Z-27
(2014)

PETITION NO: Z-27

ZONING COMMENTS:

STAFF RECOMMENDATIONS

ZONING PLAN EOR:

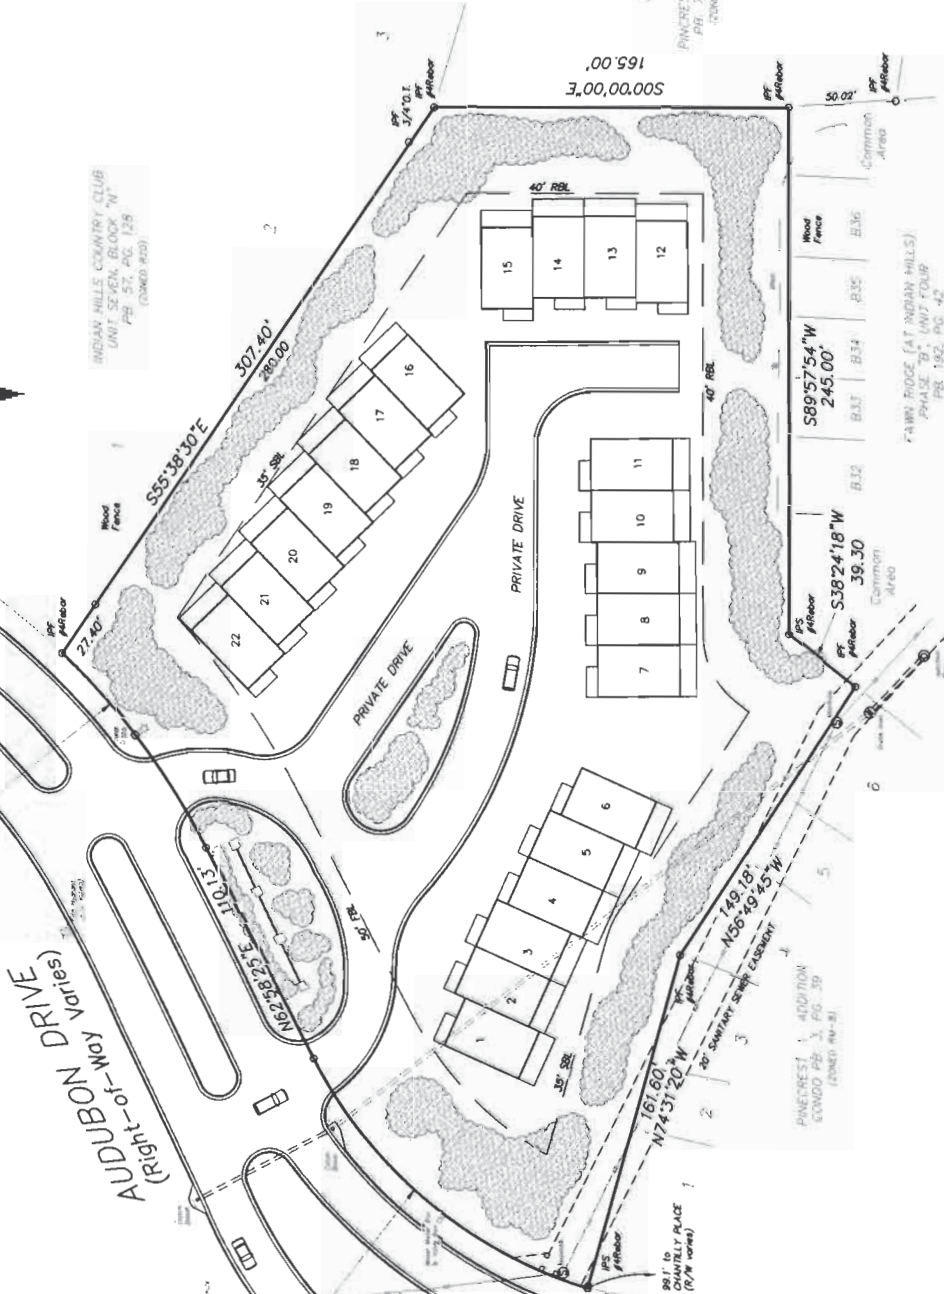
There is a required 25-foot landscape buffer required along the north property that is not shown.

- No Stormwater controls shown _____
- Copy of survey is not current – Additional comments may be forthcoming when current site conditions are exposed.
- No site improvements showing on exhibit.

- Maximum of 5 units per acre, which yields 14 lots;
- 25 foot landscape buffer be installed along the north property line adjacent to the R-20 zoned properties;
- Final site plan be approved by the District Commissioner;
- Fire Department comments and recommendations;
- Water and Sewer Division comments and recommendations;
- Stormwater Management Division comments and recommendations;
- Department of Transportation comments and recommendations.
